THE NATIONAL BOARD
OF BOILER AND PRESSURE VESSEL INSPECTORS

NATIONAL BOARD INSPECTION CODE SUBGROUP INSTALLATION

MINUTES

Meeting of July 16, 2024
Louisville, KY

FIGURE S3.6.1-a

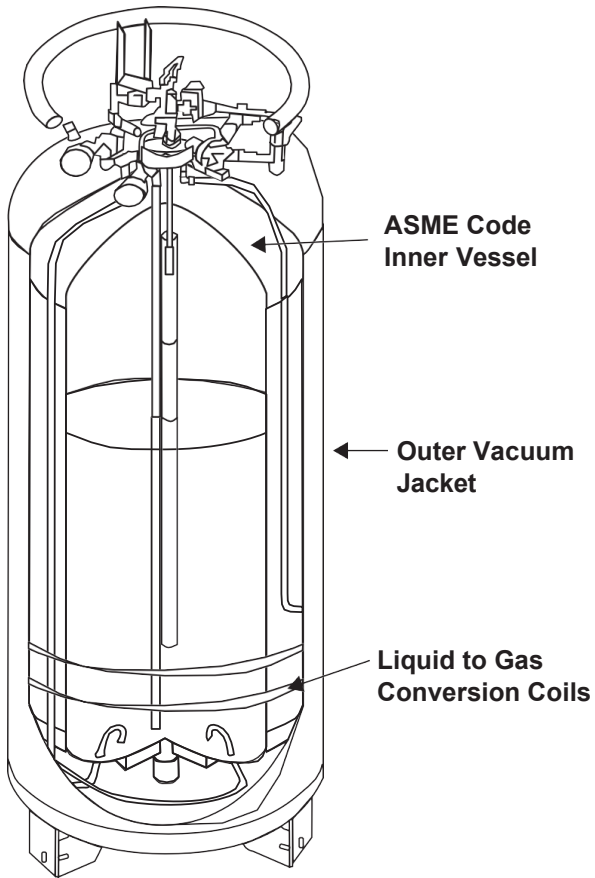
See ~~the attached Figure S3.6.1-b for a CO₂ phase diagram CO₂ Phase Diagram NBIC Part 1; Figure S3.6.1-b,~~ showing the typical operating range of these systems. Components external to the LCDSV inner tank pressure vessel may encounter pressures and temperatures between 90 psig, and -56°F, to 300 psig and +2°F, respectively {between 620 kPa, and -49°C, to 2,068 kPa and -16°C, respectively}. Typical operating pressures and temperatures vary in each of the associated sub-system circuits. (See NBIC Part 1, Table S3.6.1.)

FIGURE S3.6.1-b
CO₂ PHASE DIAGRAM

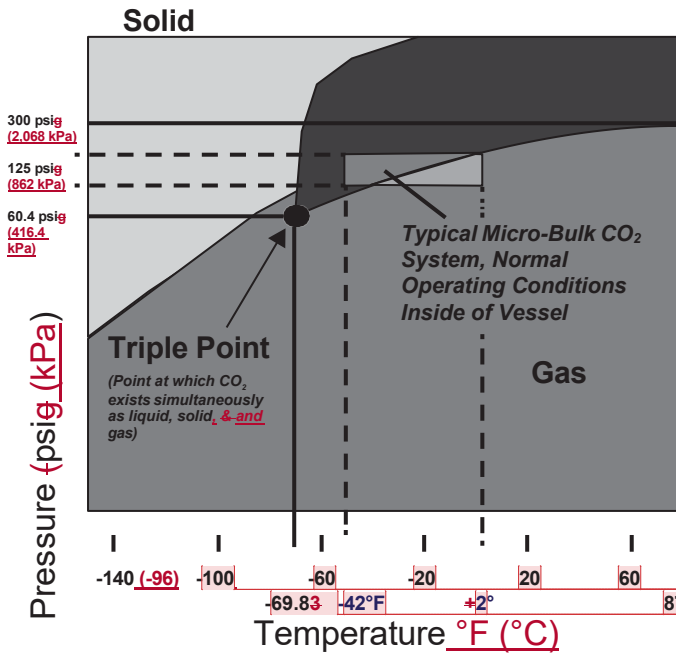
Commented [MV1]: Note: the comments below are the equivalent Celsius temperatures to add next to or below the Fahrenheit temps

- Commented [MV2]:** Add -(73) to this
- Commented [MV3]:** -51
- Commented [MV4]:** -29
- Commented [MV5]:** -7
- Commented [MV6]:** 16
- Commented [MV7]:** 56.6
- Commented [MV8]:** -41
- Commented [MV9]:** 7
- Commented [MV10]:** 30
